Our Ref: 81536-CUR-XX-XX-T-TP-00005-P01

Re: 138245/NMC/2023 – NOMA Plots 2 & 3 Angel Square

Curtins has been appointed on behalf of NOMA (GP) Limited to provide traffic and transportation advice in relation to the redevelopment of 2 & 3 Angel Square.

At the time of writing, there have been further changes to the consented scheme, with those pertaining to traffic and transport summarised as follows. These changes (hereafter referred to as ‘the 2024 changes’) are proposed to be formalised through another NMA.

Figure 1 – Changes Between 2023 NMA and 2024 NMA

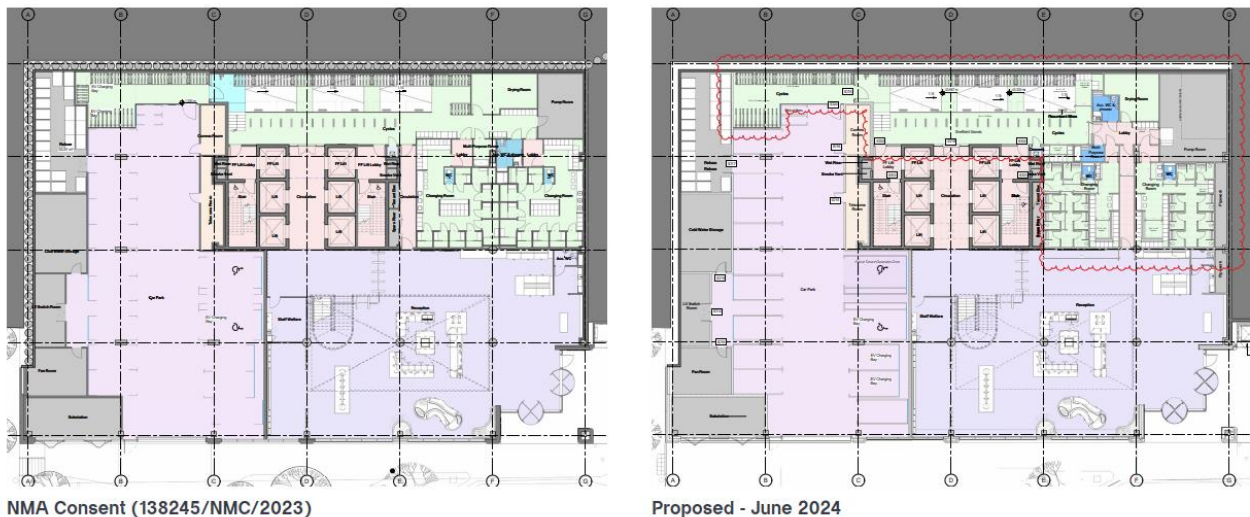
The main changes to the layout of Plot 2 with regard to traffic and transport are predominantly on the lower ground (LG) floor, and are described as follows and shown in **Figure 1** and a comparison is provided in **Appendix A** to the rear of this note:

- Number of car parking spaces reduced to 14 (including 2 EV and 2 disabled), plus 2 motorcycles;
- Cycle store layout readjustment to increase the number of cycle spaces to 180, comprising:
 - 18 folding bike lockers;
 - 96 semi-vertical bike racks;
 - 18 Sheffield stands (totalling capacity for 36 bicycles);
 - 6 recumbent bike storage; and
 - 24 two-tier cycle racks;
- Changing room layout adjusted to increase number of showers to 18;
- Locker arrangement adjusted to increase number of lockers to 191; and
- Introduction of lobby to changing rooms and access route from main reception.

GA Plan - LG Floor - Comparison

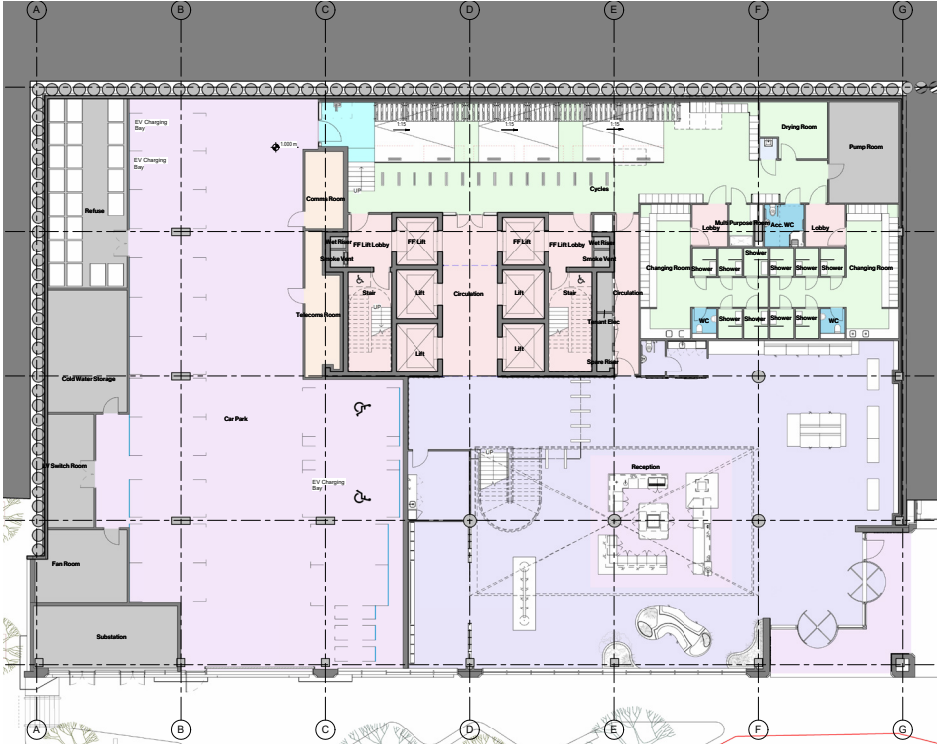
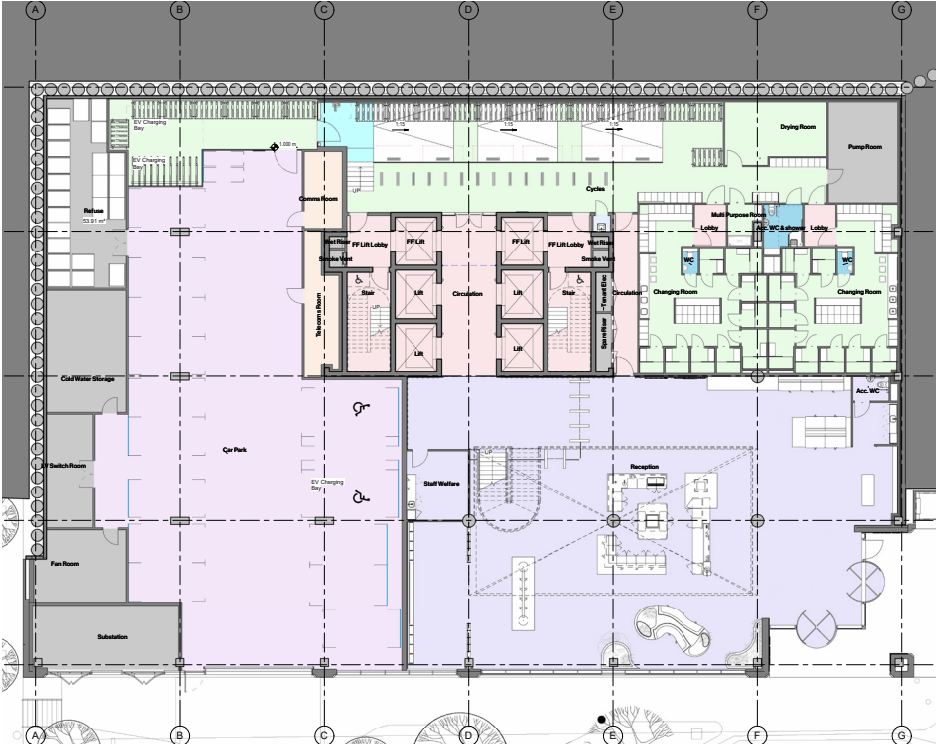
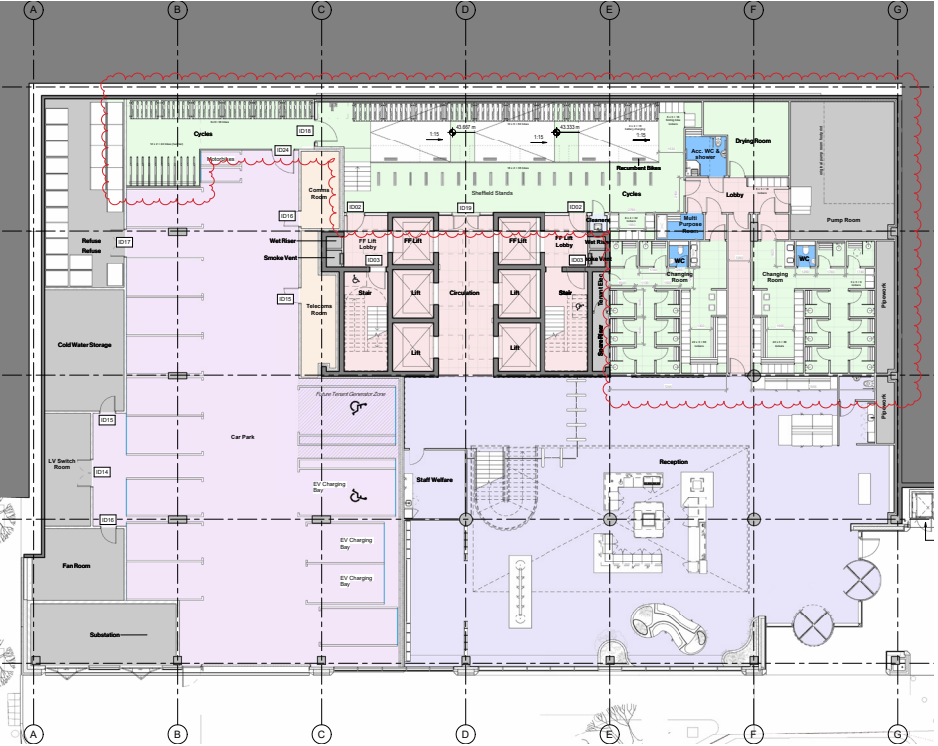
Cycle parking:	108
Shower numbers:	12
Lockers:	158
Car parking:	15
Motorbike parking:	3

Cycle parking:	198
Shower numbers:	20
Lockers:	202
Car parking:	14
Motorbike parking:	2

Cycle parking:	180
Shower numbers:	18
Lockers:	180
Car parking:	14
Motorbike parking:	2
